Memorandum

To: MPO Policy Board
From: Sandy Shackelford, Director of Planning & Transportation
Date: June 14, 2021
Reference: Smart Scale Round 5 – CTAC Discussion Summary

CTAC Hydraulic Road/Route 29 Intersection Improvement:

CTAC Rivanna River Bicycle and Pedestrian Crossing:

US 29 / Hydraulic Road Intersection Improvements
Overview (elevated roadway deck hidden)

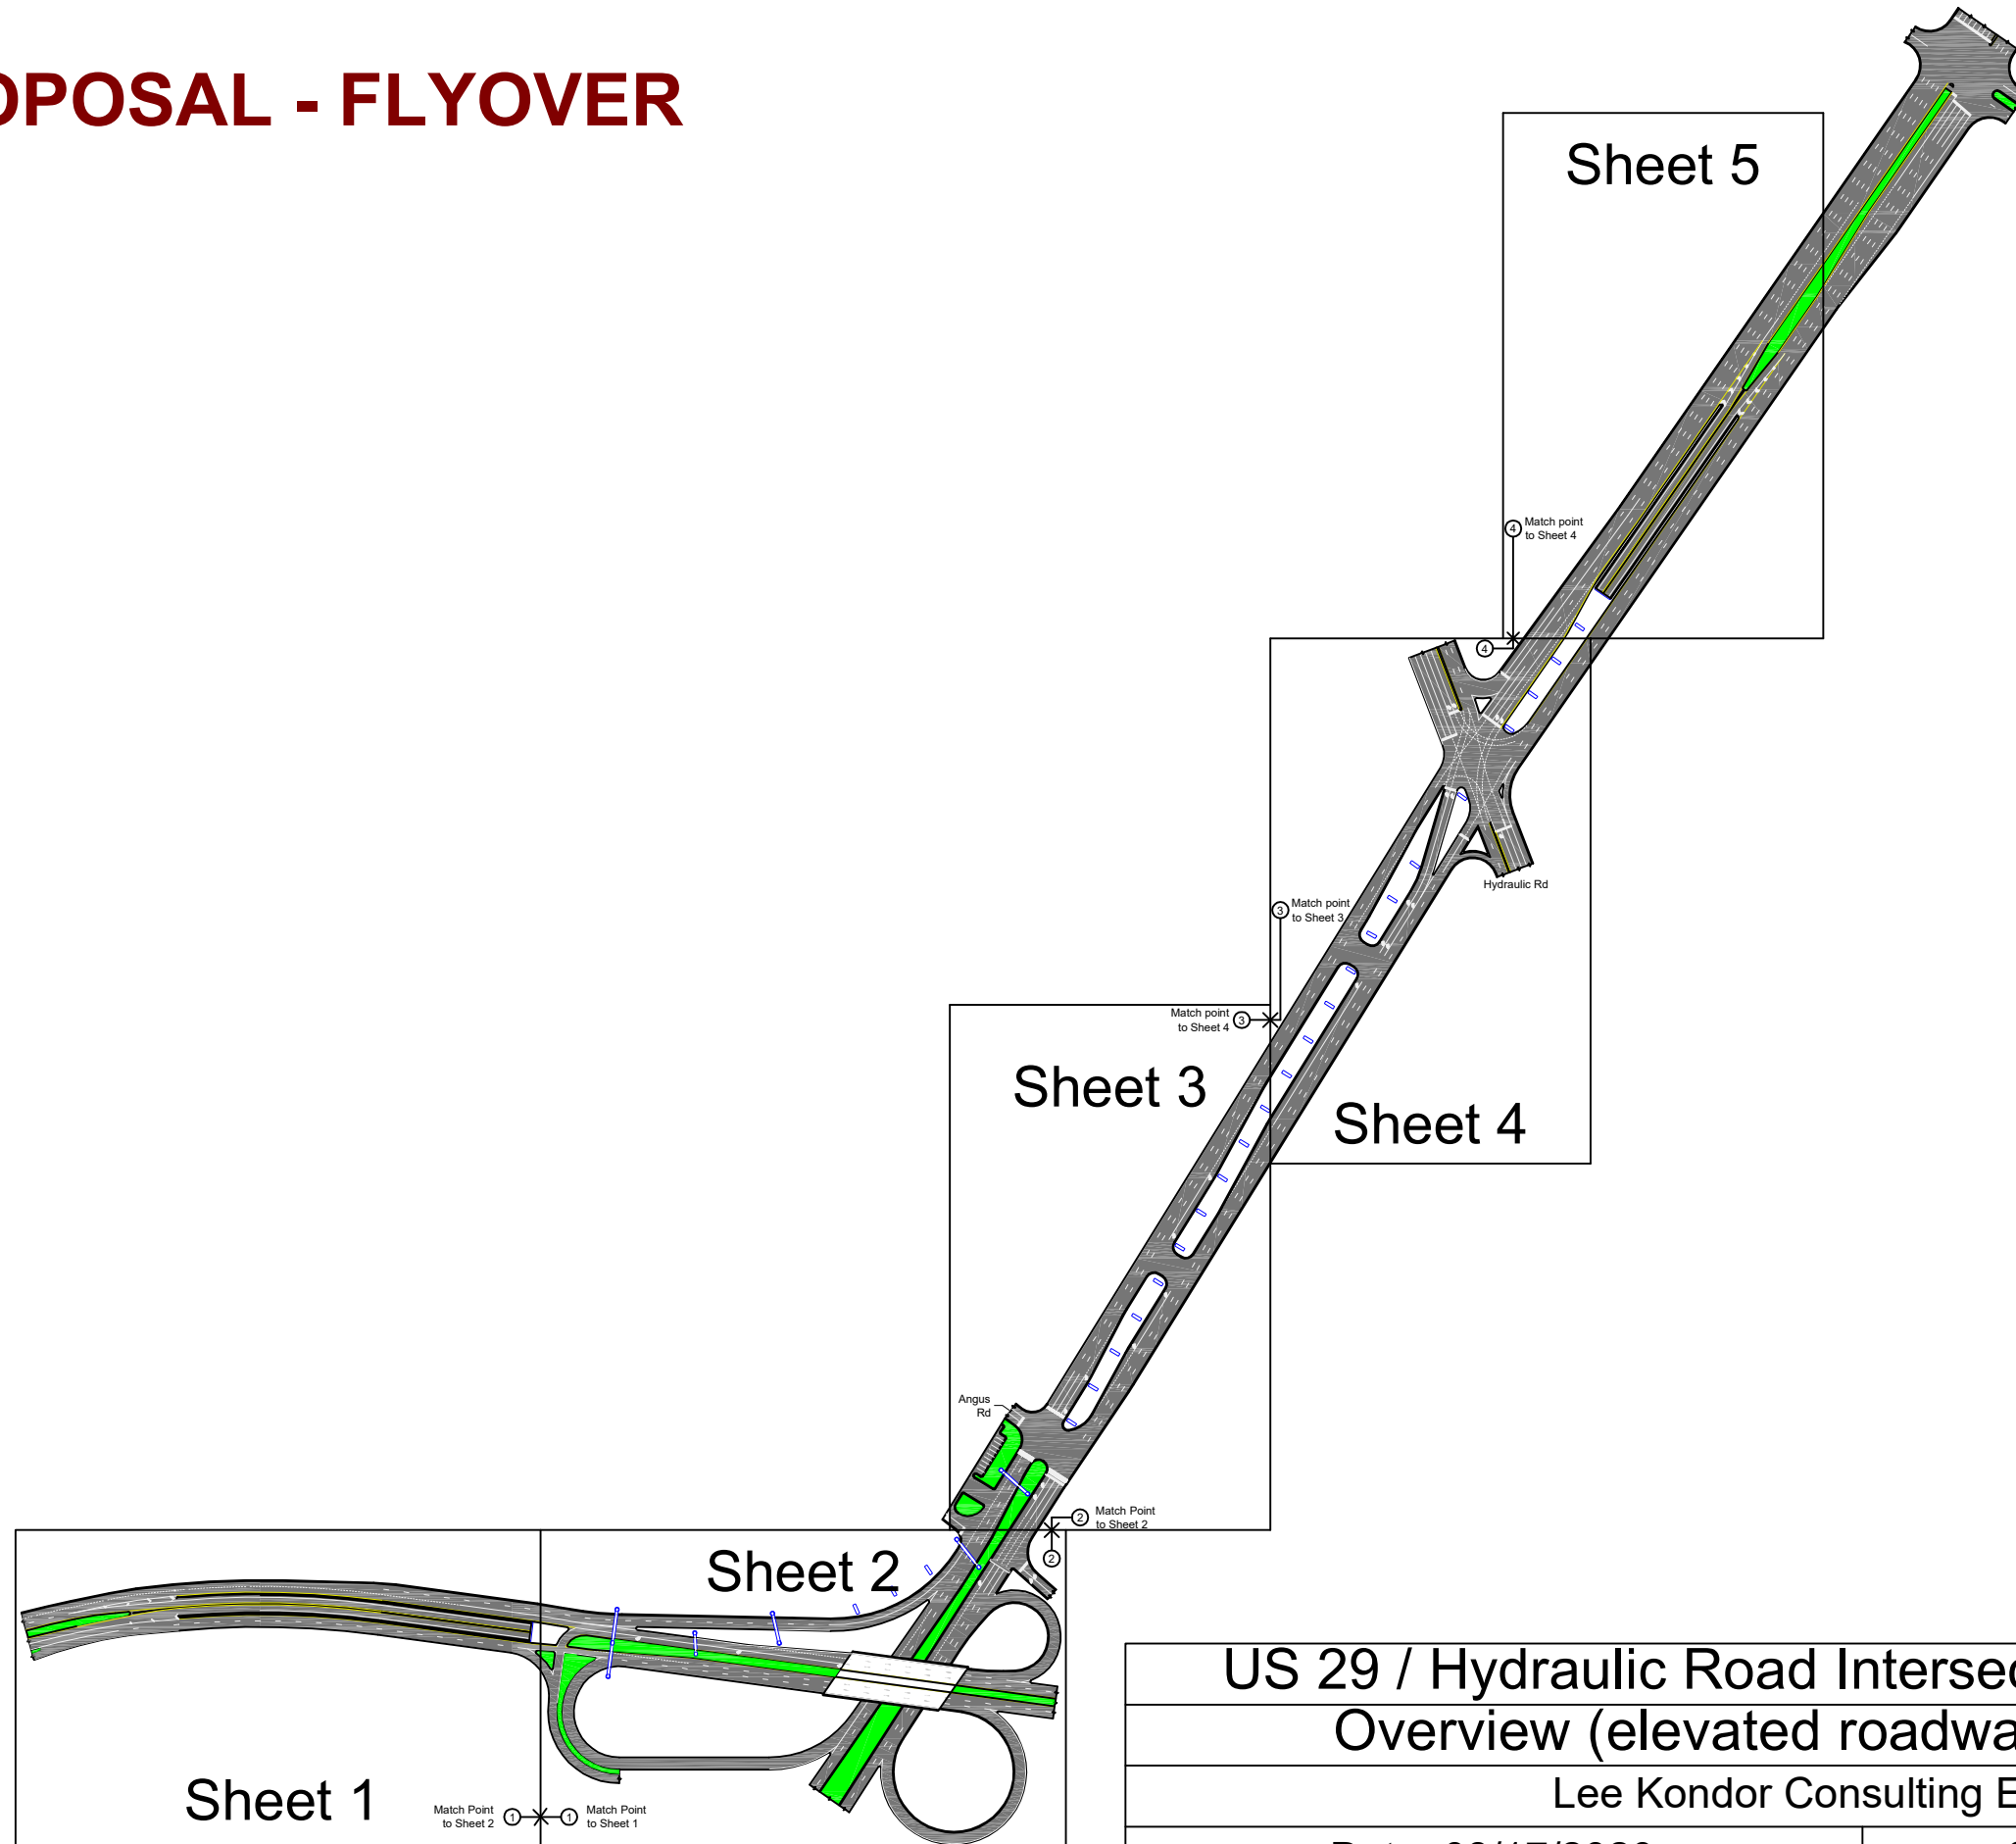
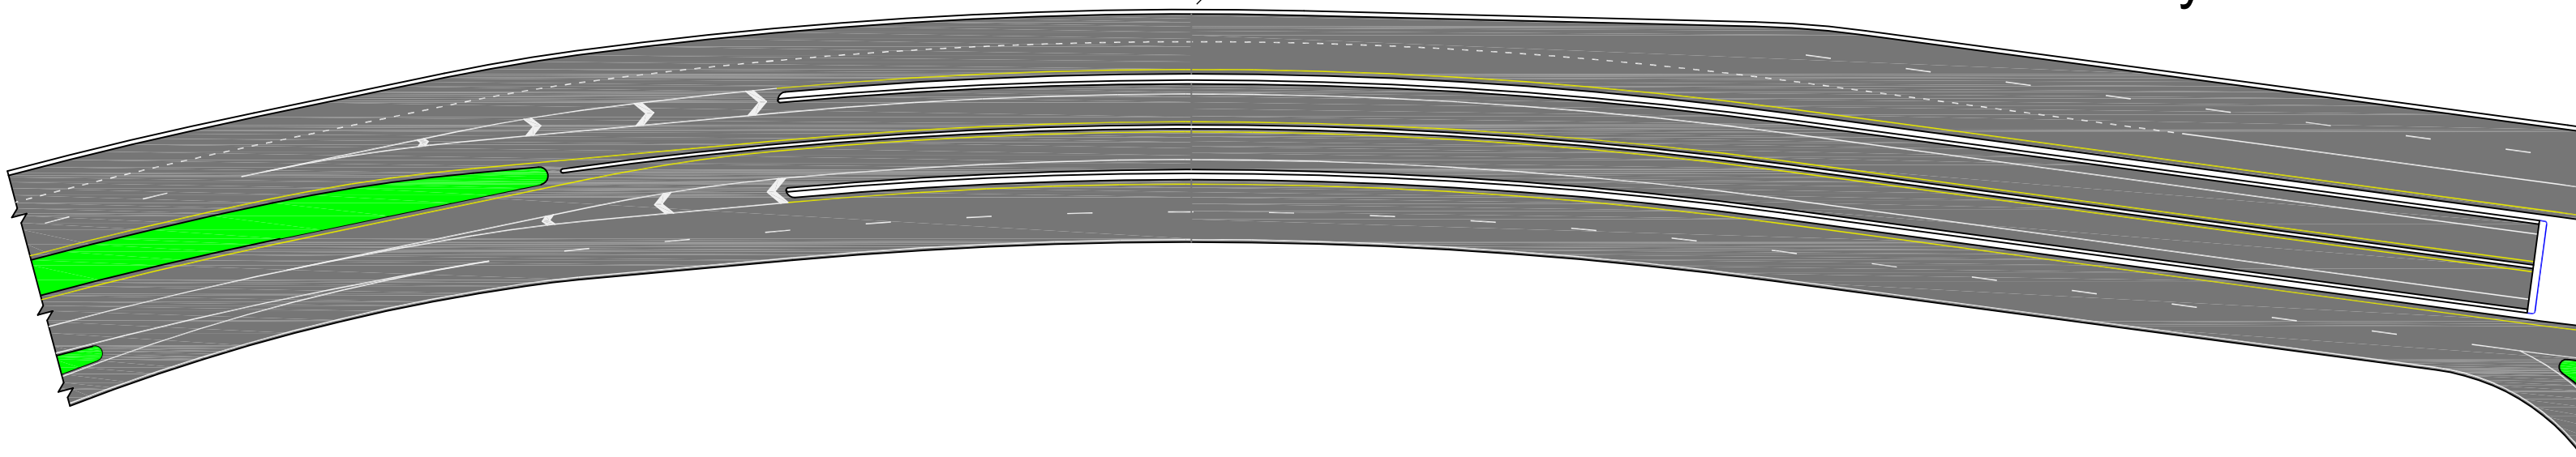
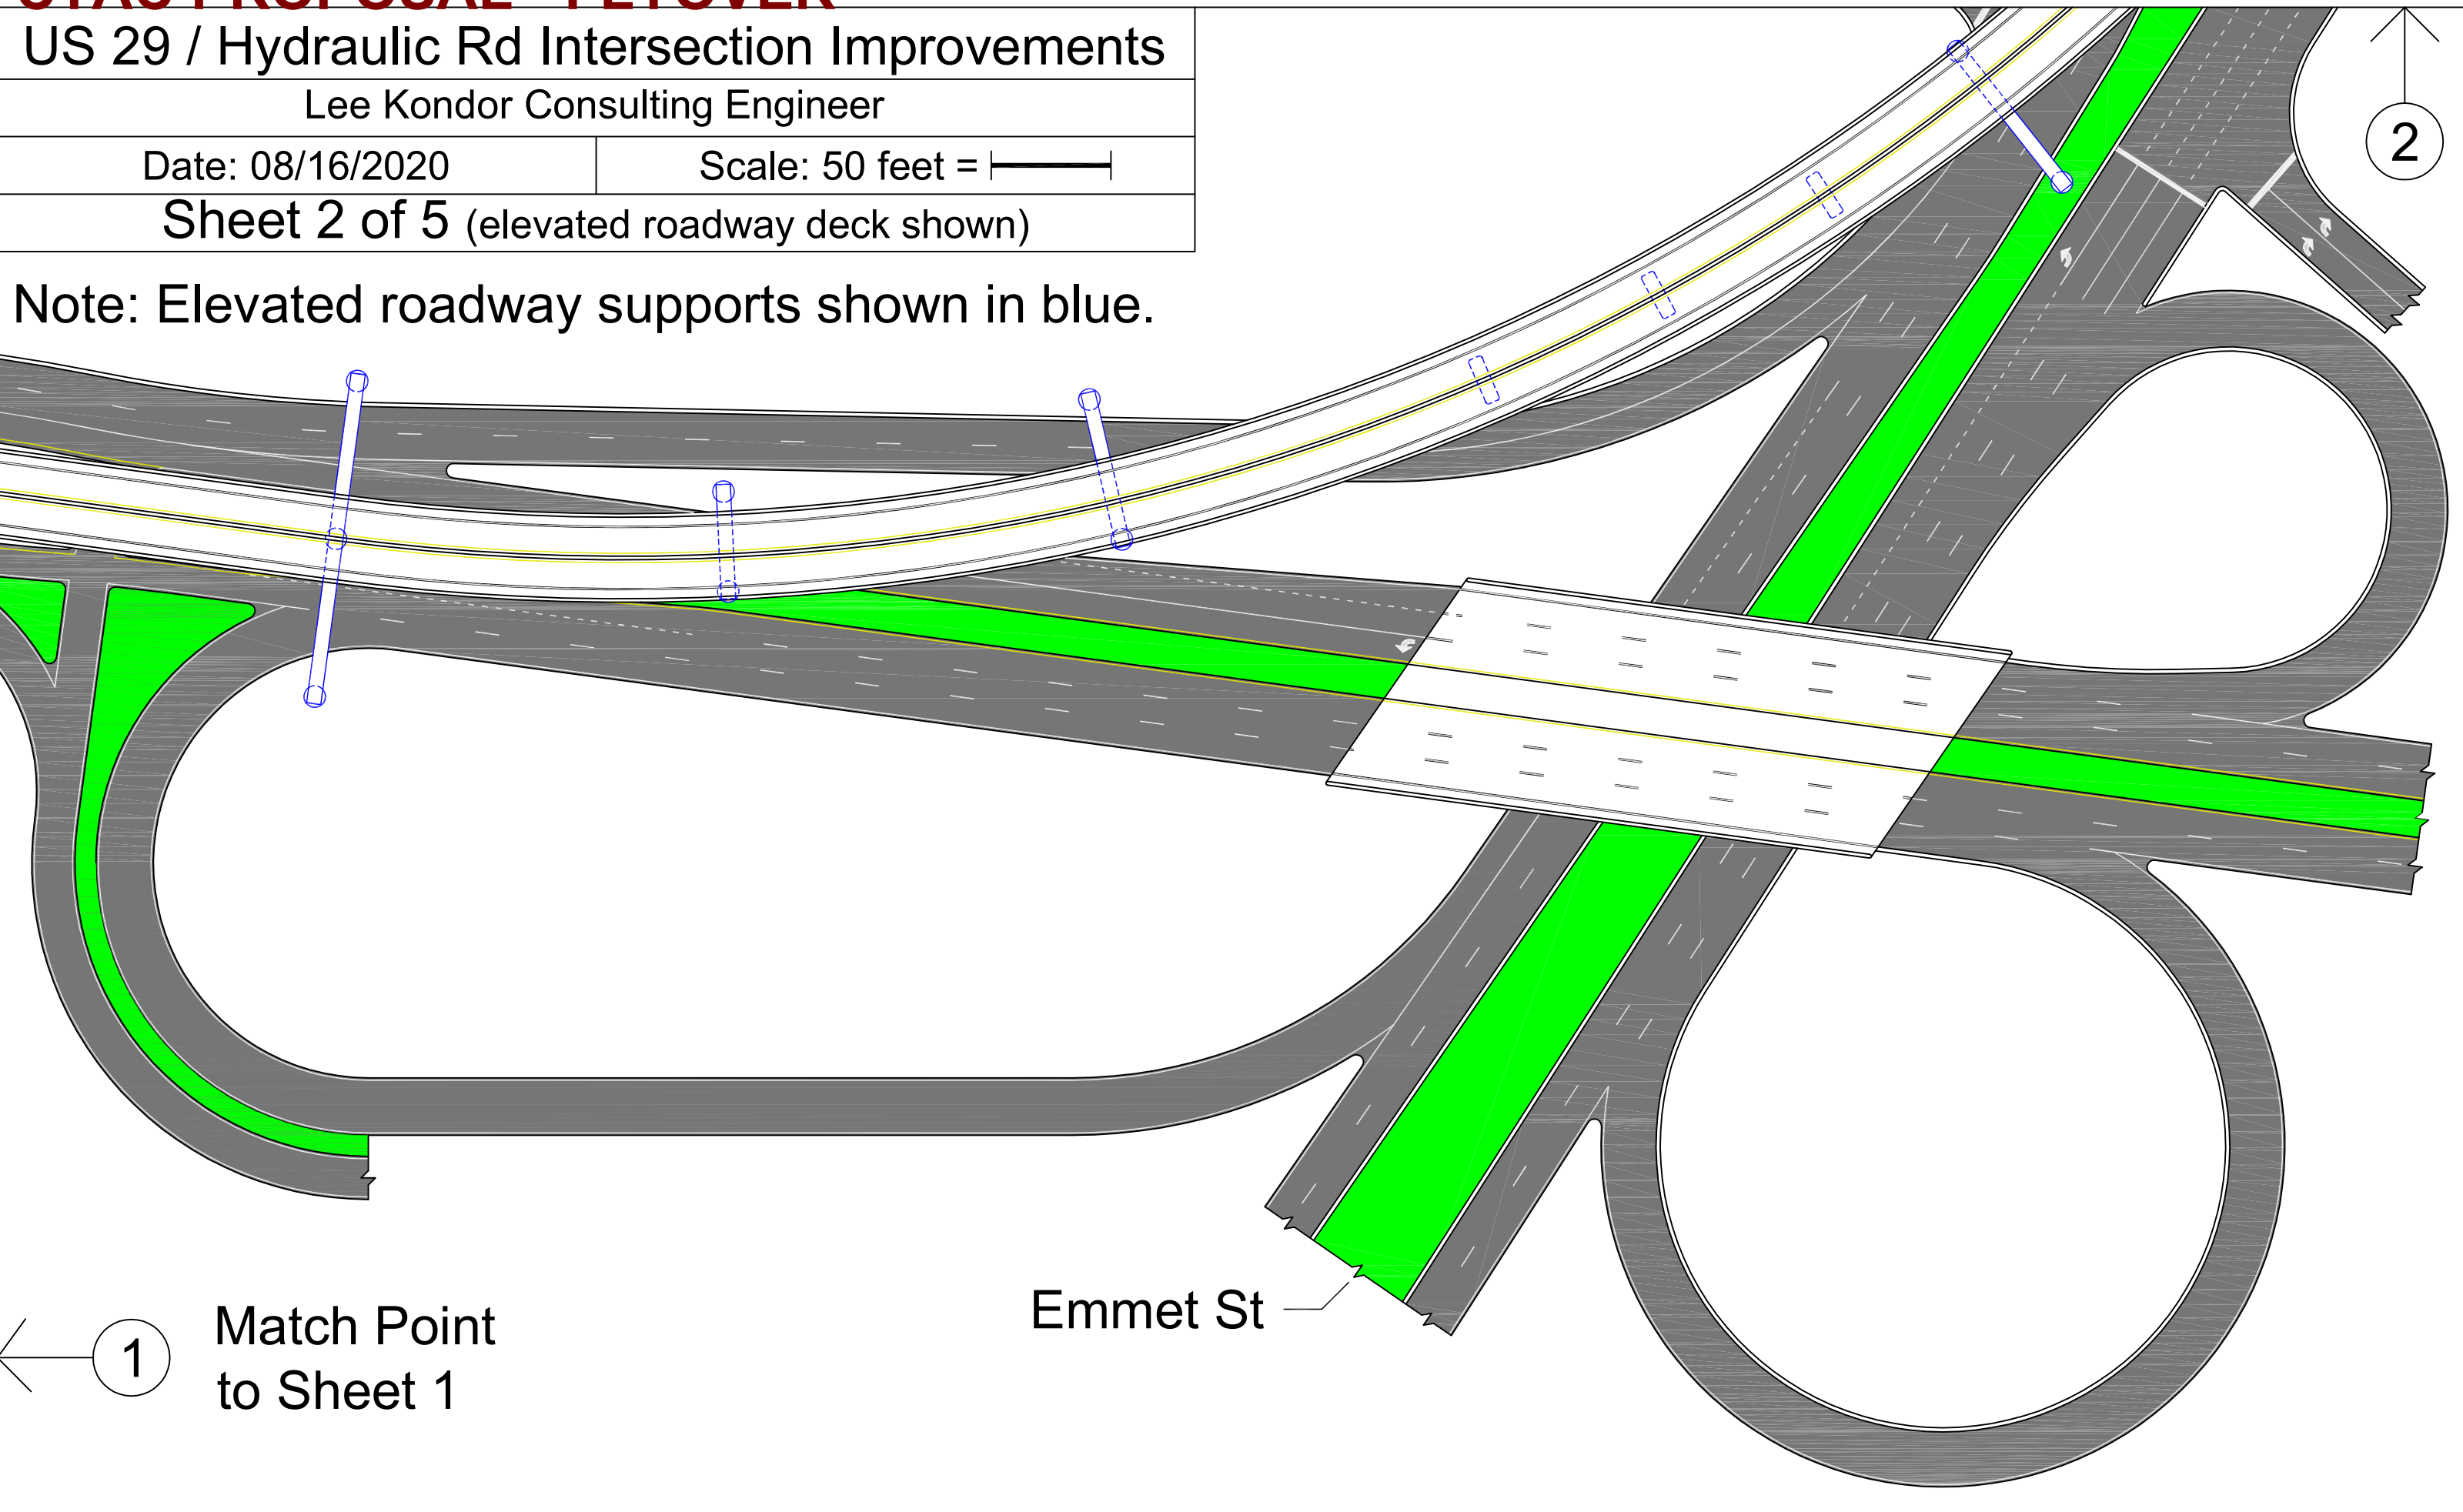
- Appreciation for the work Mr. Kondor put into developing the proposal.
- Concerns regarding the financial implications of pursuing this alternative intersection design considering the likely impacts to the Hydraulic/29 intersection improvements awarded in Round 4 and the loss of the Solutions 29 funding that was applied to that application.
- Concerns regarding the use of the 29 median to construct the proposed ramp and how that could limit future opportunities to potentially expand transit service along US 29.
- A desire to prioritize other projects that would support the development of multi-modal infrastructure.
- Concern that the proposed configuration would make pedestrian movements more challenging across US 29.
- Concerns regarding the safety of the ramp during adverse weather conditions.
- Concerns regarding the length of construction and impacts on local businesses.

- The proposed project would have congestion relief benefits by removing through traffic from the section of Emmett Street from Hydraulic Road South.
- It is unlikely that this project is eligible for funding since improvements to the Hydraulic Road/US 29 intersection were recommended for funding in SMART SCALE Round 4. To pursue this project, the MPO would have to decline the previous award and forego the \$18 million of Solutions 29 money that was allocated for congestion relief in the area prior to submitting this as an application. This application would replace the entirety of the previously awarded application, which includes the Hydraulic/29 intersection improvements, the Zan Road bike and pedestrian bridge, shared use paths along Hydraulic Road from Brandywine Drive to Michie Drive, and the roundabout at Hydraulic Road and Hillsdale Drive.

- The cost estimates have not been verified by VDOT staff, and it is possible that the estimated cost for the project would increase upon a VDOT review.

- The City of Charlottesville has extreme reservations about an elevated roadway/bridge system at this location within the City based on the initial costs as well as future maintenance, inspections, and eventual replacement expenses.
- A similar design was considered as part of the Solutions 29 Advisory Panel and was not recommended to move forward by the panel at the time that the final recommendations were developed.

No action is requested from the Policy Board at this time. CA-MPO staff will include the CTAC-proposed flyover concept to the list of potential projects for consideration by the Policy Board at their meeting on July 28, 2021. If there are any questions or comments, please contact Sandy Shackelford at sshackelford@tjpd.org.
